Technical Note

Our Ref	22024-TN-7-R0
Date	13 April 2025
Author	Andrew Jameson
Client	Domis
Issued To	Domis

St. Michaels (Ph3 Bl.A), Manchester Planning Condition 8: EHO Response

Section through spandrel/vision panel mullion

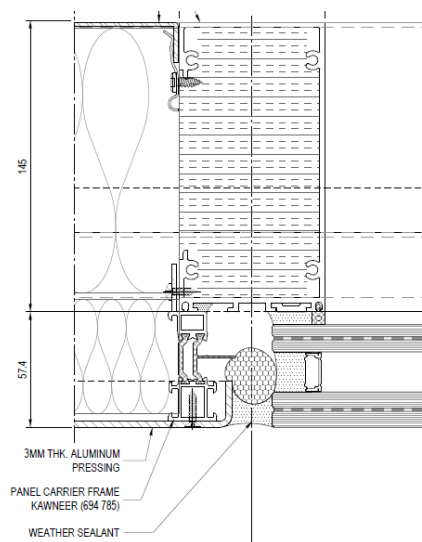
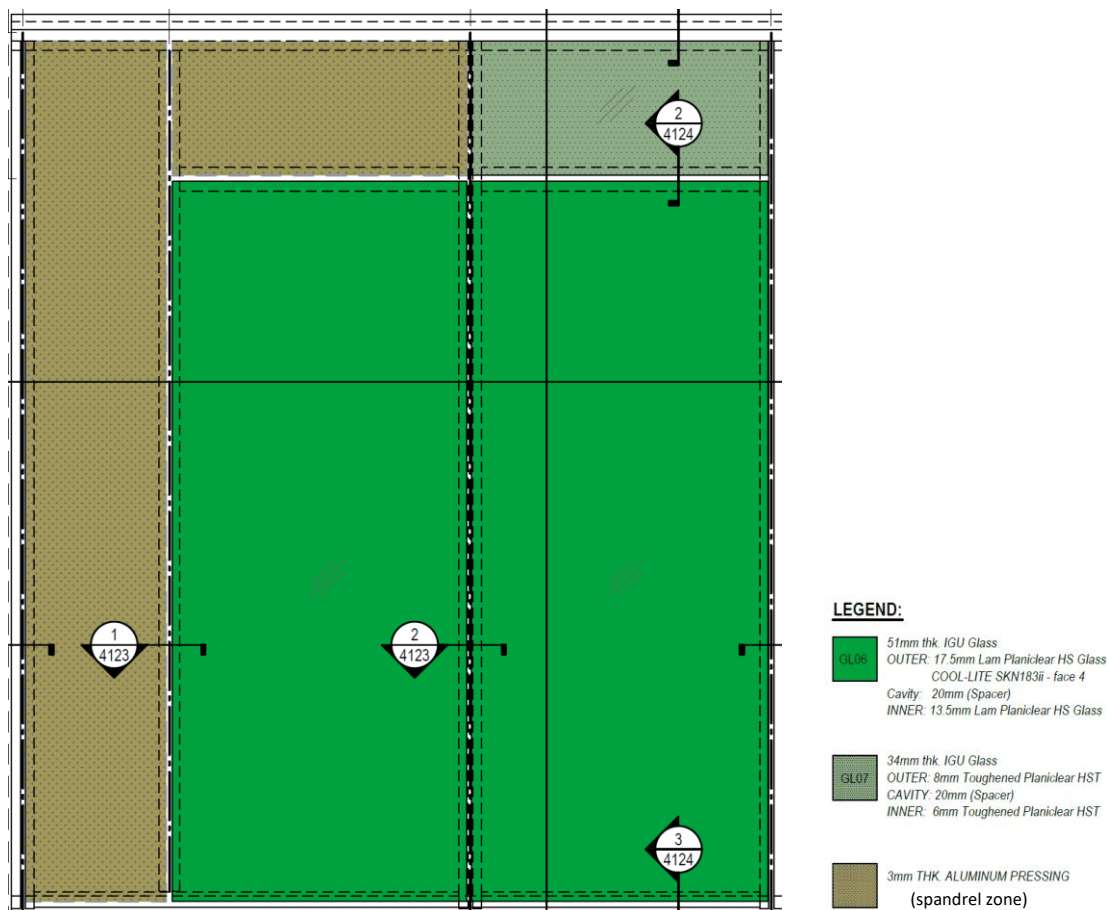
1. *MCC_ We will need examples of glazing build ups / glazing systems required to meet the performance criteria identified on page 7 of the assessment including in the report.*

JA_ The façade system will be provided by FK Group (the project's façade contractors). FK Group are proposing a unitised curtain walling system in aluminium frames constituting glazed vision panels and solid spandrel sections as follows:

- 51mm thick insulated double glazed vision panels comprising:
 - 17.5 mm laminated Planiclear HS glass (Cool-Lite SKN183ii);
 - 20 mm spacer cavity;
 - 13.5 mm laminated Planiclear HS glass.
- Shadow zone glazed sections comprising:
 - 8 mm toughened Planiclear HST;
 - 20 mm spacer cavity;
 - 6 mm toughened Planiclear HST.
 - NB: Shadow zones concealed from the room by slab edge and ceiling detail.
- Solid spandrel sections comprising:
 - 3 mm outer aluminium sheeting;
 - Ca. 200 mm dense Rockwool insulation;
 - 2-6 mm galvanized steel inner sheeting.

These constituting parts are highlighted on the below plan and section details.

The above configuration is proposed to all areas of the tower (to all three performance zones).

The final thickness of the steel inner sheeting of the spandrel will be determined through laboratory testing (see comments against item 2 below). Provisions exist to introduce acoustically-enhanced plasterboard linings to the back of spandrel zones, if required, which will be determined through laboratory testing.
